First Revision No. 8019-NFPA 5000-2024 [Detail]

Committee: BLD-SCM

Figure 38.5.1 Hail Exposure Map. (Source: Haag Engineering)

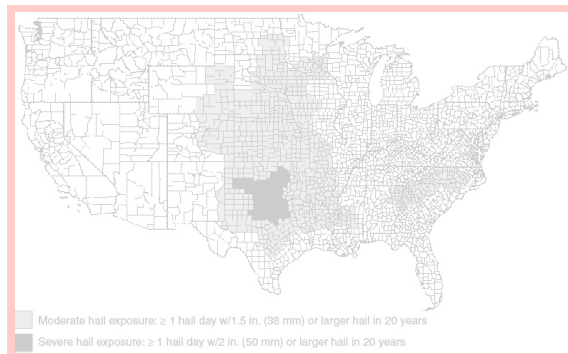
The A hail exposure map shown in Figure 38.5.1 shall be used to determine the hail exposure specified in 38.5.1.1 and 38.5.1.2.
